Doc. Type: Draft disposition of comments

Title: Draft disposition of comments on SC2 N 4239 (PDAM2.2 text to ISO/IEC 10646 3rd edition)

Source: Michel Suignard (project editor)

Date: 2012-10-15

T7. Page 114, Row 1F68: Transport and Map Symbols.

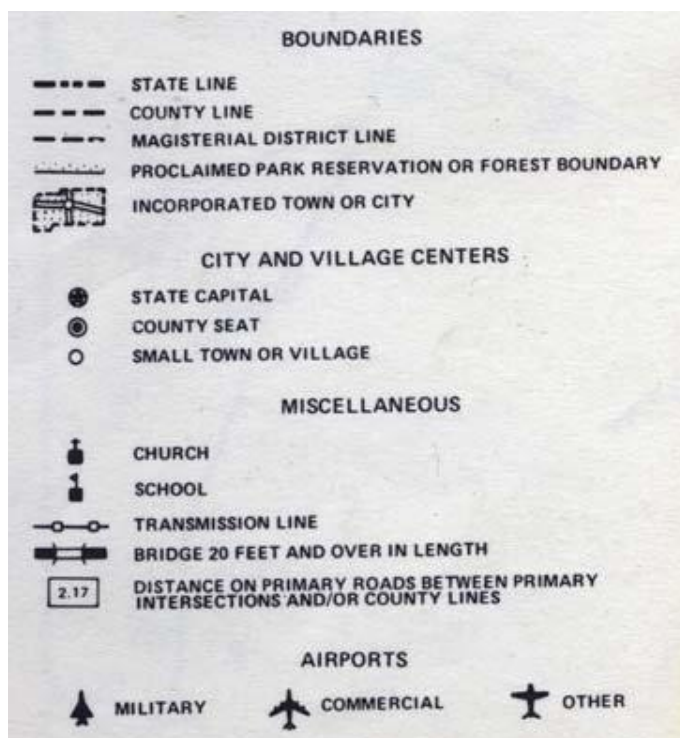
Ireland requests two character additions, along with additional annotations to one character already on the ballot.

1F6E6 MILITARY AIRPLANE

- military airport

1F6E7 UP-POINTING AIRPLANE

- commercial airport

1F6E8 SMALL AIRPLANE

- airfield

The postscript name for 1F6E8 SMALL AIRPLANE is “planesmall”, indicating a kind of small aircraft. the Webdings glyph shown in perspective is hard to identify and too “pictorial”. Further, we have found evidence for the SMALL AIRPLANE character used not only as a Webdings dingbat, but as a Transport and Map symbol used alongside MILITARY AIRPLANE and UP-POINTING AIRPLANE to indicate different kinds of airports.

At the bottom of the legend here three airports, “military”, “commercial” and “other” are indicated with three types of aircraft. The map from which this legend comes is a map of Northampton County published in 1989 by the Virginia Department of Transportation in cooperation with the U.S. Department of Transportation’s Federal Highway Administration.

Propose partial acceptance

One should not read too much in the postscript names of Wingdings and Webdings. These names were not publicly available and most users have put these characters in documents expecting the glyphs to stay close to their original design. The expectation when encoding the Webdings and Wingdings characters is to only replace their glyph if the substitution is acceptable when the only change to a document is re-encoding from the original private use area to a regular area. For example, many recent glyph changes have consisted in going from black figures to outlines and resizing.

In that aspect the proposed glyph change for the small airplane is too radical. It seems preferable to keep the small plane as it is (or at least with minimum changes) and to add another character to complete the requested set to represent the full set shown above.

This would result in three additions.
